Submission and Officer response – CAMWEST

Hawkesbury Active Transport Plan Feedback

Attachment 2 – Assessment of Industry Submissions - CAMWEST

Marked-up section of The Plan’s Figure 8 - Current network, where blue lines represent current shared paths.

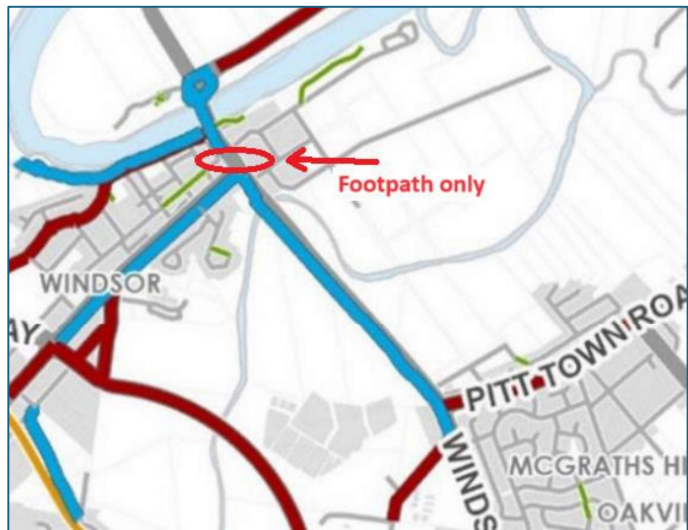
1. A section of Bridge St is currently footpath only.

As can be seen from the circled area on the image to the right, a short section of Bridge St between Macquarie St and George St is not marked as an existing shared path (blue line). Part of this section consists of a 1.35m wide footpath.

The traffic signals at the Macquarie St crossing only have pedestrian lanterns, and not bicycle or combined lanterns. In figure 39, the missing section from Figure 8 appears to be included in the S1 route – but the S1 route is marked as ‘existing’ (which is correct apart from this short section). This section is required to link to the Windsor Bridge and the on-road Cycle Route 8 – Windsor to Wilberforce.

Response 2	
<p>Page 2 of Submission</p> <p>Footpath on Bridge Street not marked in Figure 8.</p>	<p>These comments have been noted. When progressing these routes Council is required to prepare detailed design drawings where any anomalies such as this will be addressed.</p>

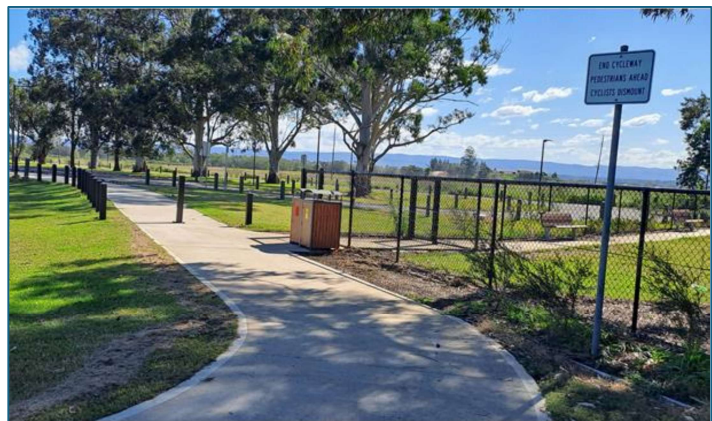
2. River Walk and Cycle track alongside The Terrace and to Deerubbin Park

The River Walk pathway appears to have been built in several stages over a period of time. The paved section at the eastern (Windsor township) end is around 1.9m wide. Heading west the next concrete section which runs to just before the Rickabys Ck bridge is 2m wide. The section across Rickabys Ck into Deerubbin Park is 2.5m wide. A couple of sections along the paved path are fenced-off due to river bank erosion from the 2022 floods. There are dirt tracks around these fenced-off areas.

If these eroded areas are not planned to be repaired in the foreseeable future, we'd like to see a new pathway (approximately 20m in length) with a kerb ramp to The Terrace roadway constructed near the Fitzgerald St intersection. The current pathway to the roadway has some tight turns and is missing the kerb ramp, so is not particularly enticing for riders.

Response 3	
<p>Page 3 of Submission</p> <p>Request for new 20m pathway along eroded areas along River Walk and Cycle Track alongside The Terrace and to Deerubbin Park.</p>	<p>As noted by CAMWEST, the River Walk pathway has been built in several stages.</p> <p>This item will be referred to Council's Infrastructure Services Directorate for their estimated timing of repairs to bring the pathway back to original condition, if the repairs are linked to disaster funding which has strict guidelines on works permitted or if construction of a 20m pathway is a consideration.</p> <p>Note that if construction of a 20m pathway was to occur and no disaster funding has been awarded, this project would be subject to funding and prioritisation amongst other/all Council projects.</p>

'Cyclist Dismount' sign when approaching Deerubbin Park from the River Path.

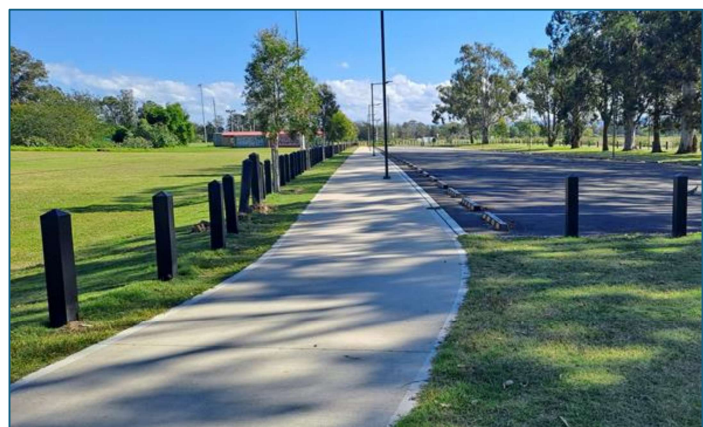
We were very disappointed to see the sign 'End Cycleway. Pedestrians Ahead. Cyclists dismount' when entering the park. While the old path was reclaimed for the revamped car park and a new 2.5m wide path built parallel to where the old path ran, there is no real 'exit' from the shared path to the car park – and definitely not before the 'Cyclist dismount' sign. At the time we visited, there was one person with a dog using the path. This is NOT the way to encourage active transport. We view every time a rider needs to dismount as a disincentive to riding. We totally agree with dismounting if there are lots of people and or dogs around and there's a real chance of causing an accident. A 'Caution' type sign makes sense in these situations.

Maybe we missed it, but we didn't see a sign coming from the opposite direction – apart from the main sign for Deerubbin Park saying 'No Cycling'.

Response 4	
<p>Page 3 of Submission</p> <p>Deerubbin Park River Path cycleway signage concerns</p>	<p>This item will be referred to Council's Infrastructure Services Directorate to consider review of signage.</p>

Marked-up section of *The Plan's* Figure 8, showing additional paths and notes

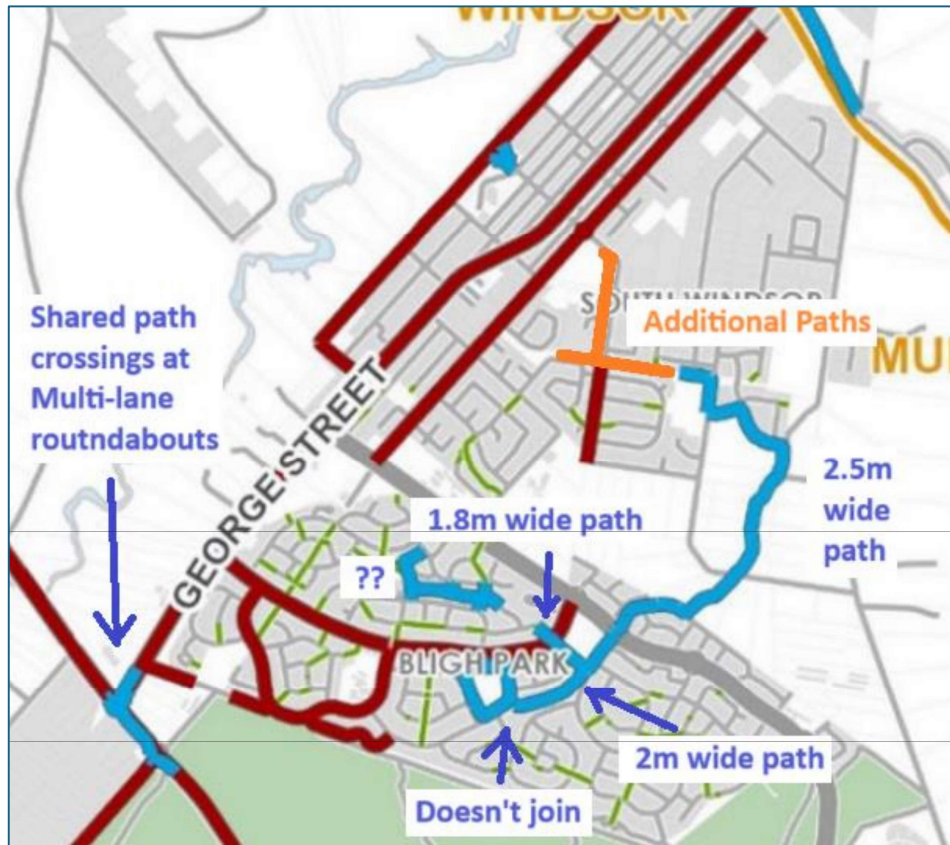
It's been good to see extensions being built to the network of paths through South Windsor over the last few years. It's unfortunate that paths partly constructed just 'end' with no proper linkages back to the nearest roadways. The latest section from Stewart Rd towards Batten Circuit is one example, but the path along Drummond St also just ends. (There are proposals to extend both in *The Plan*).

The new concrete path ends metres before Batten Circuit. We think it's meant to go through to Mileham St.

We were previously unaware that the paths on the above mark-up that we've labelled as '??' were meant to be shared paths. We didn't investigate on our recent visit, but looking on Google Street View they appear to be narrower footpaths in narrow corridors. We don't believe they should be considered shared paths. When riding around we did spot some other wider corridors that could potentially have their pathways widened to create useful shared path links. Time constraints meant that we didn't have the opportunity to investigate further on the day. Has Council investigated these as possible useful linkages?

Response 8	
Page 6 of Submission South Windsor and Bligh Park Shared Paths – widening of pathways to create shared path links	These comments have been noted. When progressing these projects Council is required to prepare detailed design drawings of each proposed route. There will be opportunity to refine routes including some changes dictated by existing assets which may need to be relocated and regulations current at that time.

Barriers on new path from Stewart St heading towards Batten Circuit – slight incline.

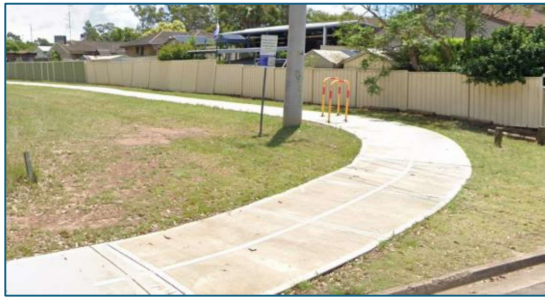
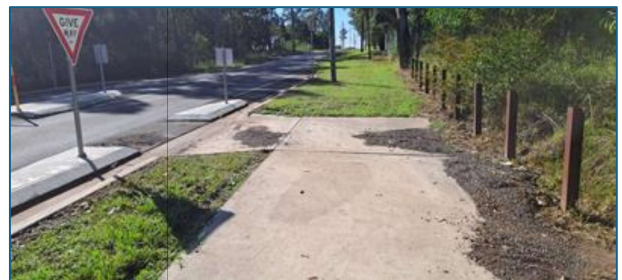
There are numerous offset barriers along the route. We see them literally as a barrier to cycling. We understand their primary purpose is to minimise egress of dirt bikes and the like. In these photos however, since there is no fencing around the barriers, dirt bikes and their ilk can simply bypass the barriers by cutting across country for a short distance before rejoining the path. Meanwhile, the bike rider on the path must negotiate very tight turns while often riding up an incline. For those of us who can't do this, we either need to shuffle around them or completely dismount and walk. There are sharp drops off the new path heading towards Batten Cct at the barriers. These can be nasty if riders overshoot the path. (Maybe all the silt in the gutters is run-off from around the path).

Encountering a few of these barriers per ride when you can understand the purpose of them may be acceptable to most, but we find it becomes quite frustrating when we experience more than a few, and the purpose of them is a mystery. Our fear is that rather than encouraging regular riding or commuting, people will be so annoyed by the number of apparently meaningless barriers that they elect to drive the car instead.

Response 5	
Page 4 and 5 of Submission South Windsor and Bligh Park Shared Path – offset barriers along the route	This item will be referred to Council's Infrastructure Services Directorate for consideration of offset barriers, their purpose and currency.

Gravel across path – and on a corner.

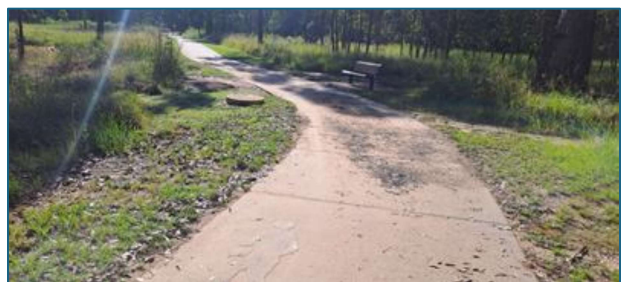
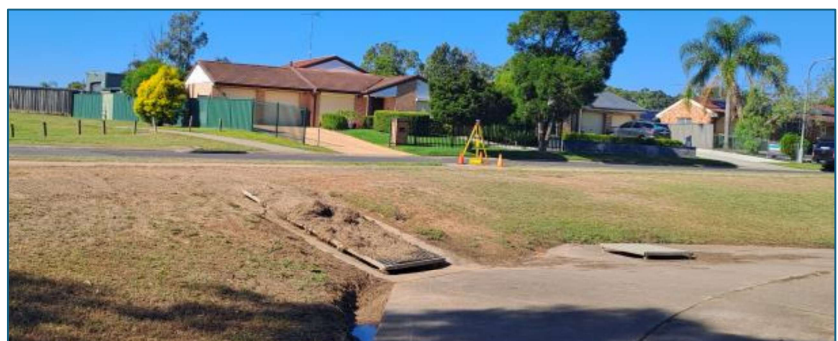
As well as water over the paths in places, we saw quite a bit of silt in a couple of locations as well as gravel in another. This may well be from the rains a week before the photos were taken so we're prepared to grant Council a bit of slack on this occasion (We remember water across the path from a previous ride but can't recall if there was silt and gravel on that occasion). As these represent a risk to riders' safety, they should be cleaned-up as soon as practicable.

Response 6	
Page 5 of Submission South Windsor and Bligh Park Shared Path – water, silt and gravel over paths along the route	This item will be referred to Council's Infrastructure Services Directorate for maintenance/clean up. Requests for these matters can also be reported by residents and road/path users via Council's website.

Looking from the 2m wide shared path around Colonial Reserve across Guardian Crescent to the end of the shared path.

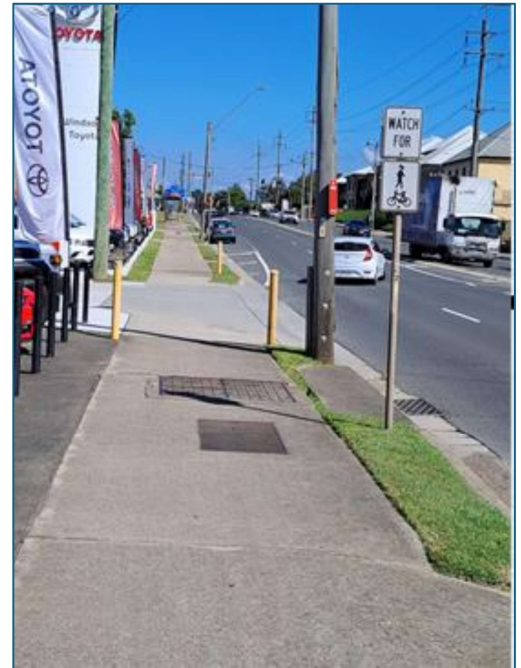
In Figure 8 of *The Plan*, the path around Colonial Reserve in Bligh Park appears to line up with the shared path running off the other side of Guardian Crescent. There is no direct 'concrete' linking the two. Riders need to take to the road for around 80m.

Response 7	
Page 5 of Submission Colonial Reserve in Bligh Park – missing link to Guardian Crescent	These comments have been noted. When progressing these routes Council is required to prepare detailed design drawings where any anomalies such as this will be addressed.

Open Street Map mark-up showing alternative Windsor to South Windsor Routes

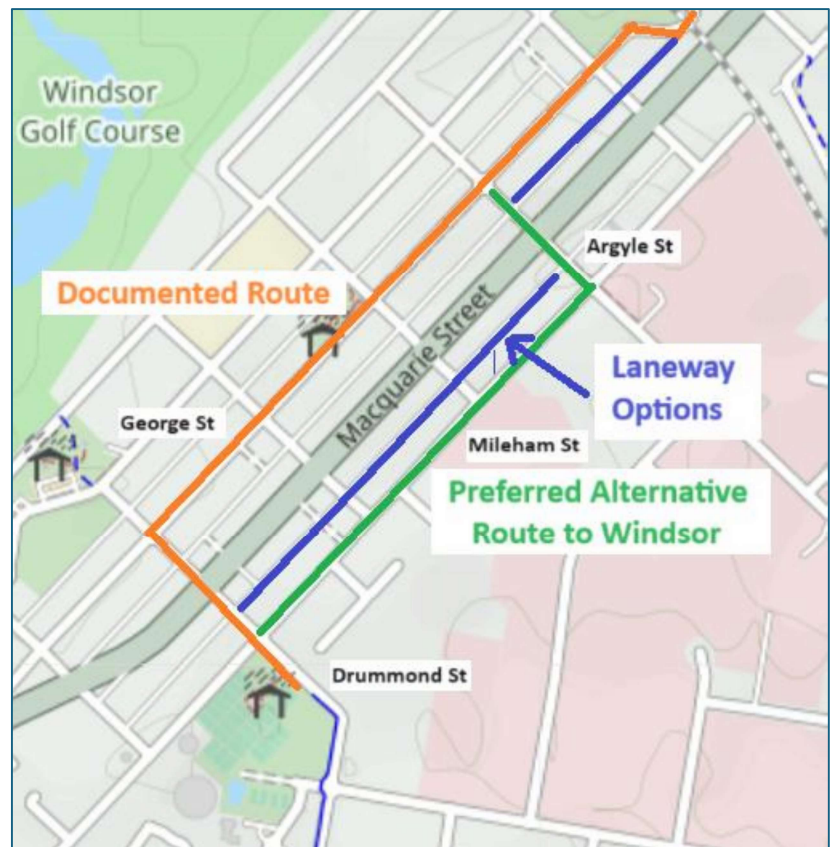
We can appreciate the reasons why the routes from Drummond St, South Windsor and along George St past the Windsor South shops might have been selected: Access from both South Windsor/Bligh Park and Windsor to Hawkesbury Oasis, Windsor South Shops, and proximity to Windsor South Primary School.

However, for those wishing to ride from Drummond St to Windsor Station and beyond, the route based on Mileham St and Argyle St is flatter and more inviting. (We quite like Eather Lane which runs parallel with Mileham Rd and Dickson Lane which runs parallel with George St, as shown on the Open Street Map markup below).

We note Mileham Rd is marked as an existing 'on-road' route. This would be our preference for a shared path route for those wishing to ride between Drummond St and the Railway Station.

Response 12	
<p>Page 8 of Submission</p> <p>South Windsor to Windsor route – comments regarding proposed route</p>	<p>These comments have been noted.</p> <p>As Council looks to investigate and prepare detail design of each proposed route there will be opportunity to refine routes including some changes dictated by existing assets which may need to be relocated and regulations current at that time.</p>

Marked Up Open Street Map image of preferred route with WC3 crossing of Hawkesbury Valley Way.

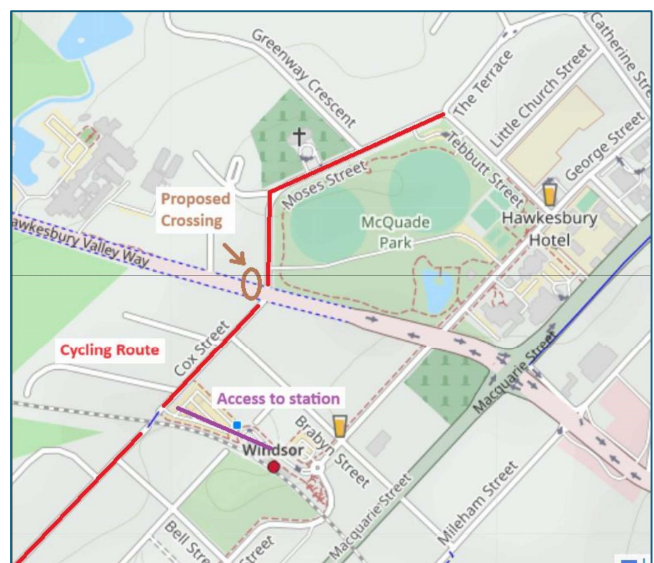
From our perspective, the WC3 Pedestrian refuge on Hawkesbury Valley Way near Cox St would be close to our highest priority. Cox St and Moses St are important on-road cycling routes between Windsor, South Windsor, and the train station. Ideally the crossing would have shared path access to both Cox St and Moses St. Although probably more expensive than the standard pedestrian refuge, we like the 'offset' variety, where several bikes (and/or pedestrians with prams etc) can wait in the centre of the road with relatively safely.

If the offset refuge is not possible, please ensure that there is enough space to safely contain a 2.3m long cargo bike in the centre refuge island.

<p>Page 9 of Submission</p> <p>Possible Additional Opportunities:</p> <p>Point 1 – Off road access from George Street in Windsor to The Terrace and River Walk</p> <p>Points 2, 3, 4 and 5 – suggestions for upgrades and improvements in Windsor and South Windsor</p> <p>Priority Suggestion – crossing infrastructure on Hawkesbury Valley Way near Cox Street</p>	<p>These comments have been noted.</p> <p>This would be subject to additional funding becoming available and separate project community consultation.</p> <p>These suggestions would be subject to funding and prioritisation of all existing projects across the Hawkesbury Local Government Area.</p> <p>As Hawkesbury Valley Way is a State road, Transport for NSW are the authority to approve any additional assets on the road.</p>
<p>Response 14</p>	
<p>Page 10 of Submission</p> <p>Closing Comments</p> <p>Bicycle lanterns at zebra crossing and pedestrian signals and traffic light sequencing</p> <p>Signage</p>	<p>These comments have been noted.</p> <p>Traffic signals are controlled/approved by Transport for NSW, as is traffic light sequencing.</p> <p>Consideration of signage is included as part of the detailed design stage of any routes/paths.</p>

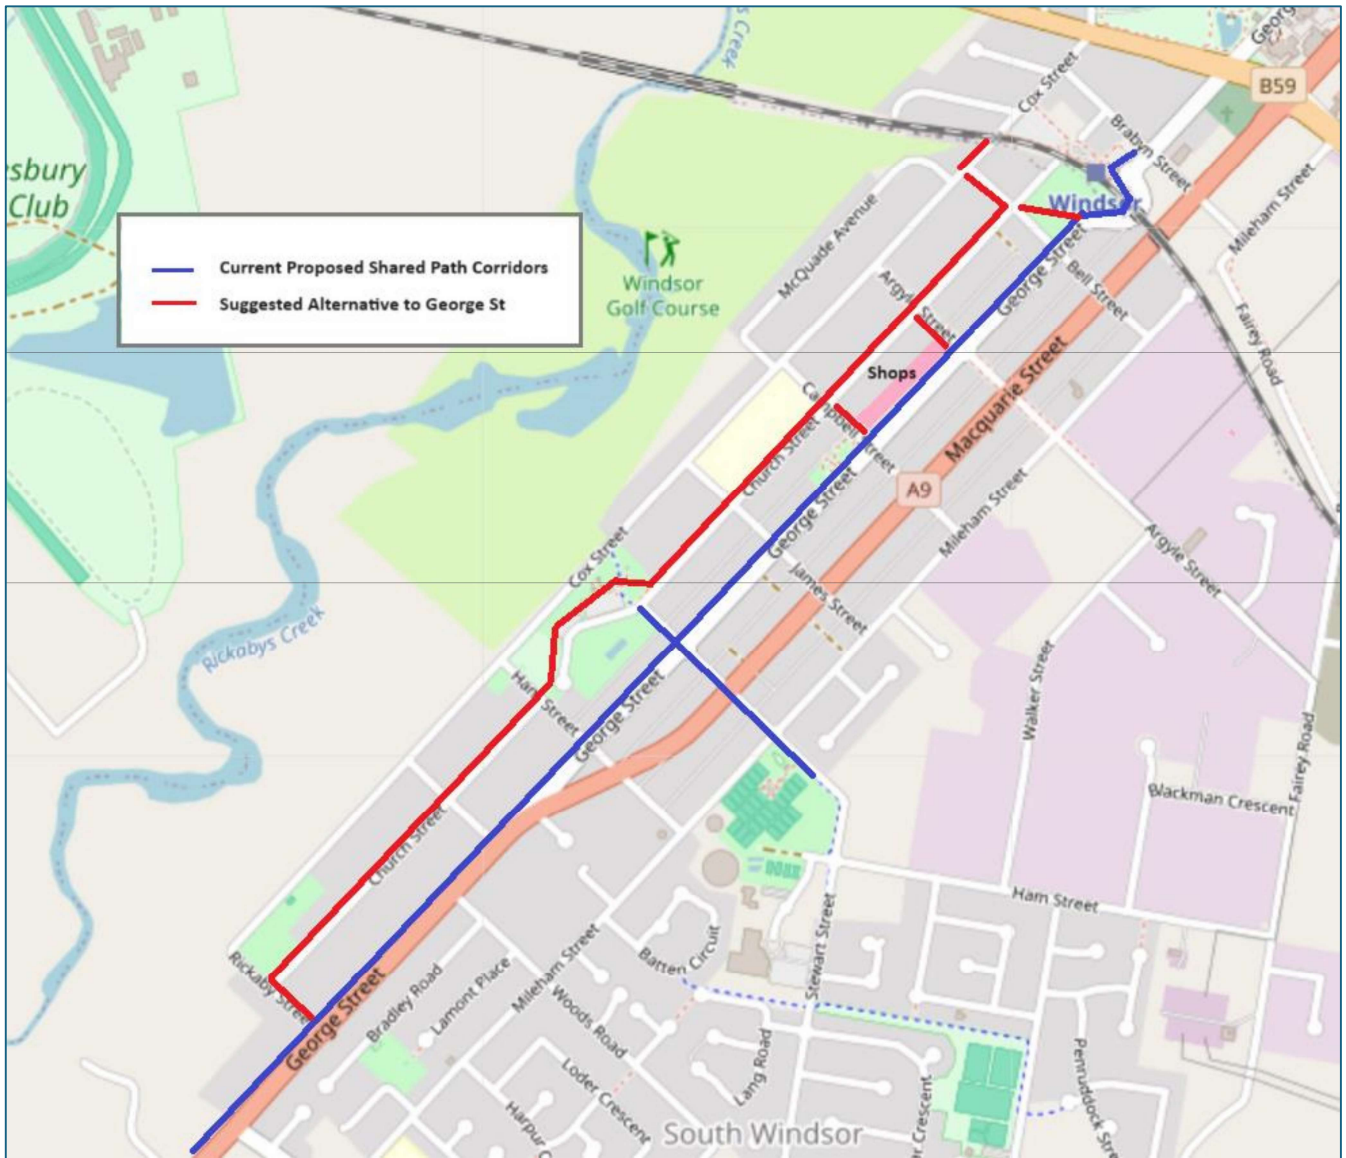
Windsor Public School: Although there are some wider paths around Windsor Public School, they don't appear to link to anywhere of significance. We can see that by crossing from the existing Macquarie St path at the Day St signalised intersection riders can get part of way along the northern side of Macquarie St on wider paths, but not to the main Dight St entrance of the school. There is also a wider path along George St between Dight St and the Hawkesbury Council access road, but it stops short of reaching Hawkesbury Valley Way where one of the proposed routes is planned to run.

Bligh Park Public School: While the proposed path along Colonial Drive goes close to Bligh Park Public School, there is a narrower footpath along part of Alexander St between the school and Colonial Drive.

Chisolm Catholic Primary School, South Windsor: There is no shared path connectivity along Collith Ave between the school and the proposed Rifle Range Rd path.

<p>Response 15</p>	
<p>Page 11 of Submission</p> <p>Access to Primary Schools – Richmond and Windsor.</p>	<p>These comments have been noted.</p> <p>When preparing detailed design drawings Council can include additional legs where required to address linkages such as those mentioned in the submission and others identified at that time.</p>
<p>Response 16</p>	
<p>Page 12 of Submission</p> <p>Hawkesbury Oasis route suggestions Windsor Shopping Precinct route suggestions</p>	<p>These comments have been noted.</p> <p>As Council looks to investigate and prepare detail design of each proposed route there will be opportunity to refine routes including some changes dictated by existing assets which may need to be relocated and regulations current at that time.</p>
